CALIFORNIA COASTAL COMMISSION45 FREMONT STREET, SUITE 2000
SAN FRANCISCO, CA 94105-2219
VOICE AND TDD (415) 904-5200**RECORD PACKET COPY****W 7a****STAFF REPORT AND RECOMMENDATION****ON CONSISTENCY DETERMINATION**Consistency Determination No. **CD-117-99**

FEDERAL AGENCY: CORPS OF ENGINEERS**DEVELOPMENT****LOCATION:**

Lower Mission Creek, Santa Barbara (Exhibit 1)

DEVELOPMENT**DESCRIPTION:**Lower Mission Creek flood-control improvements
(Exhibit 2-9)**EXECUTIVE SUMMARY**

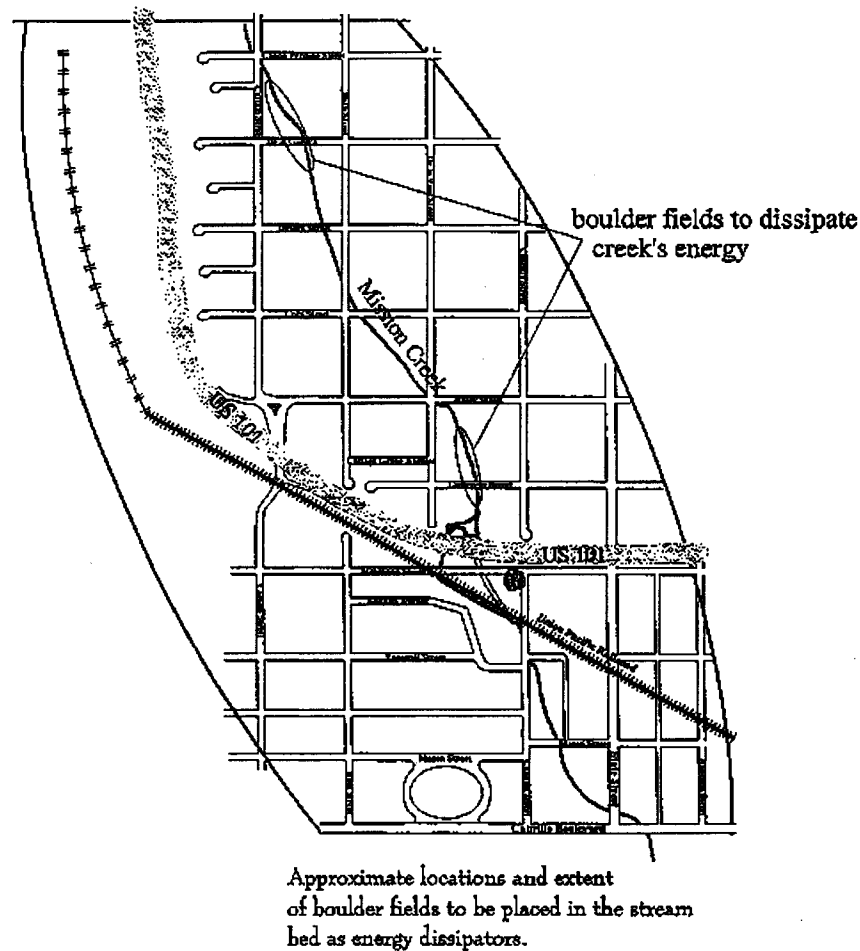
The Commission is concerned that the proposed mitigation is not adequate to address project impacts. As described above, the proposed project will significantly change the nature of the stream and estuary. These changes include potential increases in water temperature, sedimentation, and pollution and possible loss of nutrient inputs and stream bank features created at the boundary of vegetated areas and streambed. In addition, the annual maintenance activities will result in regular disturbances to this sensitive habitat. Finally, the removal of aquatic vegetation and bank vegetation within the estuary will result in a reduction in the input of nutrients into the stream and estuary. The Commission believes that these changes will significantly reduce the value of Mission Creek for both the tidewater goby and the steelhead trout. This conclusion is supported by the Corps' own analysis, which shows that the habitat value of the aquatic area will be significantly reduced.

Since the aquatic habitat supports threatened species, the Commission believes that the mitigation proposed by the Corps should focus on this resource. However, the Corps' mitigation focuses on improving bank habitat and avoiding construction impacts. Although the Commission recognizes that the Corps proposes some aquatic habitat enhancements, these benefits are inadequate to address long-term habitat impacts to the aquatic resources. The aquatic benefits

f. Develop a mitigation plan that avoids or compensates for the project's impacts to aquatic habitat. Such a mitigation plan should be developed in consultation with the Coastal Commission staff, U.S. Fish and Wildlife Service and the National Marine Fisheries Service.

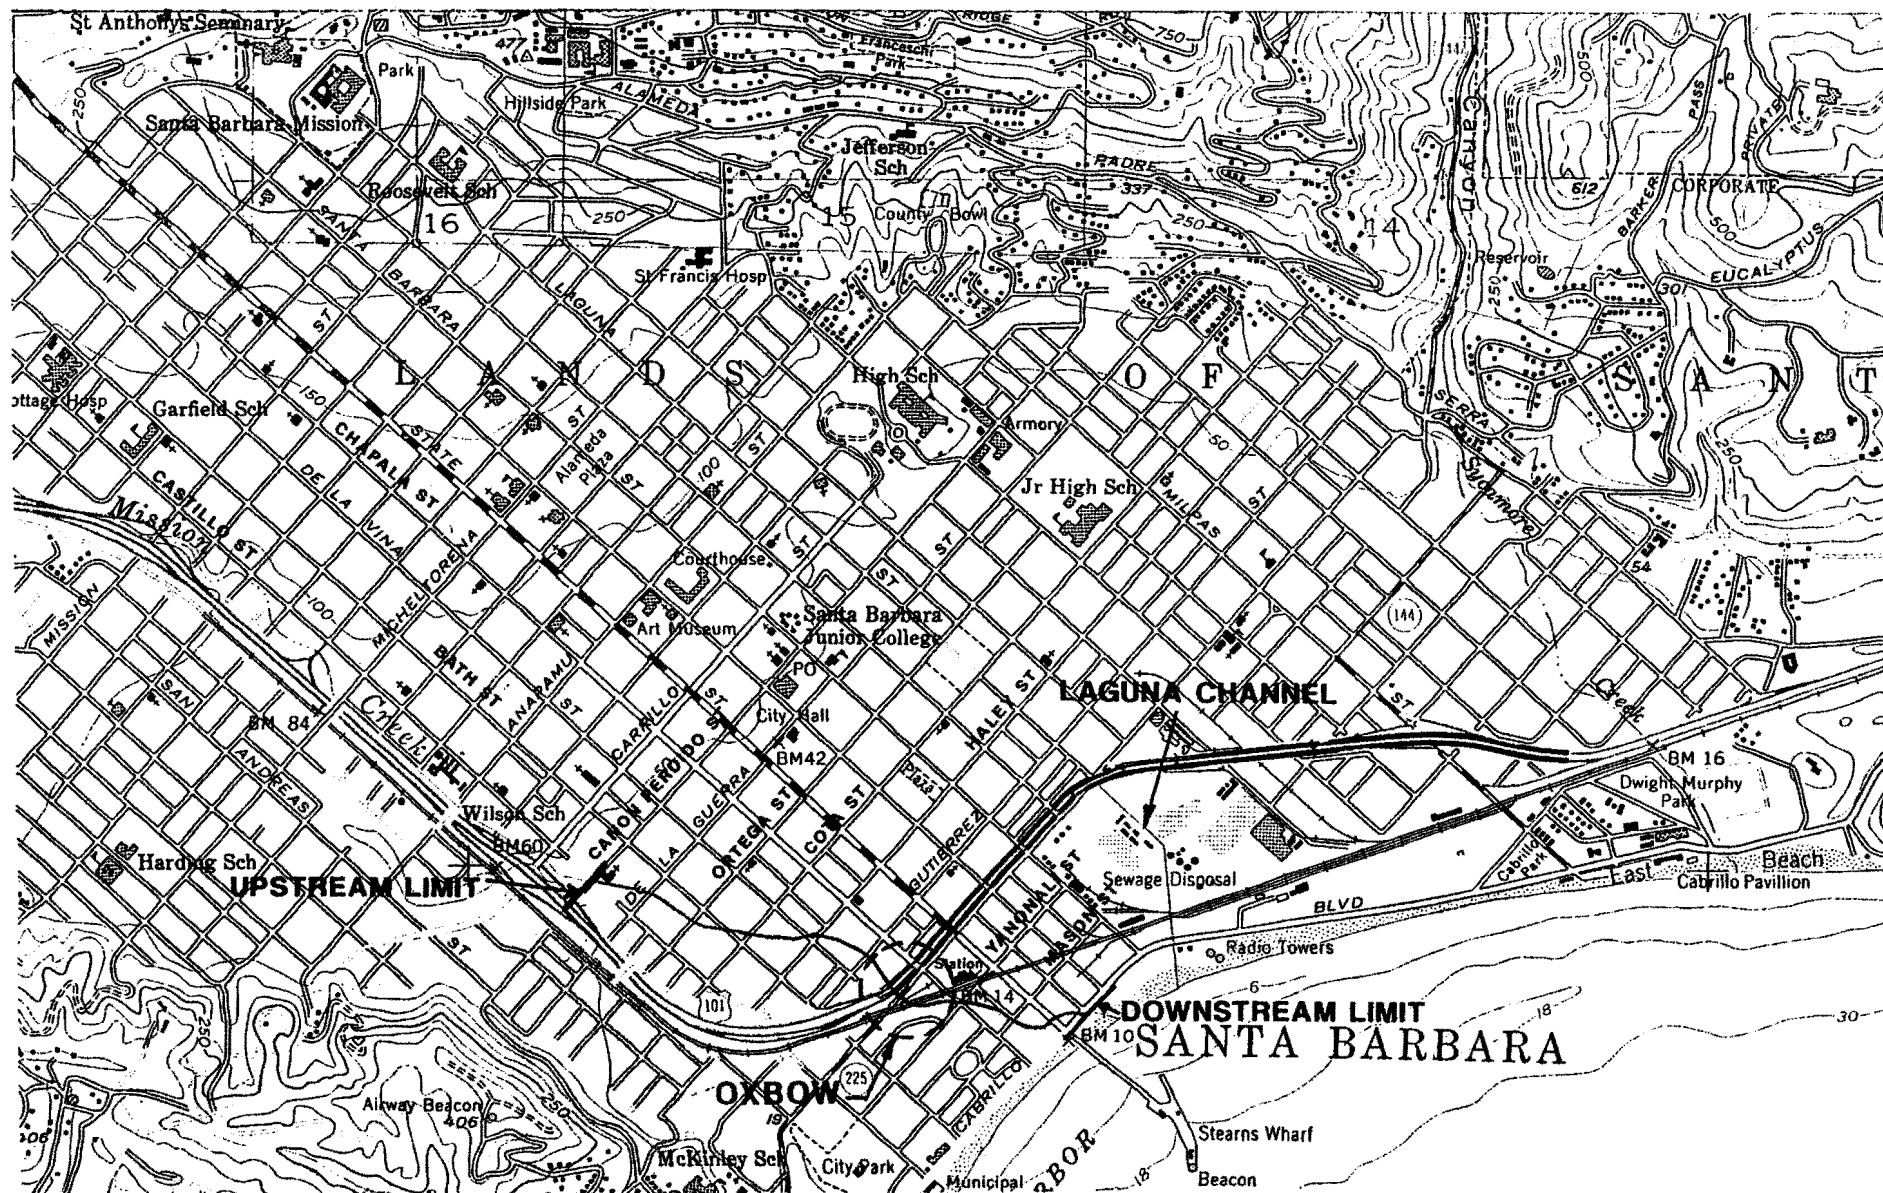
As stated above, most of the Creek within the coastal zone would be developed with vertical walls and would not appear as a natural stream. Although the area is already developed with some man made structures, it still has some natural appearance. The proposed project would change that appearance to a channelized hardened stream.

The Commission has two concerns with respect to the Corps' analysis of visual impacts. First, as described in the Habitat Section above, it is not clear that the construction of vertical walls is necessary. Until the Corps provides additional information that justifies the need for the walls, the Commission considers the use of vegetated slopes to be a less visually damaging alternative. If the Corps can demonstrate that the vertical walls are necessary, the second concern of the Commission is that aesthetic design improvements proposed by the Corps are not described in detail and the Commission cannot determine if the improvements would sufficiently mitigate for visual impacts. Without this

information, the Commission cannot determine if the project is consistent with the visual policies of the Coastal Act. Therefore, the Commission finds that the consistency determination for the proposed project does not provide enough information to determine if the project is consistent with the view protection policies of the Coastal Act.

6. **Visual Resources.** The Corps should revise its consistency determination to analyze a smaller-scale version of the proposed project that may increase the amount of vegetated side slopes, and thus reduce the visual impact from the project. Additionally, the Corps' consistency determination should include a detailed description of the project's aesthetic design features.
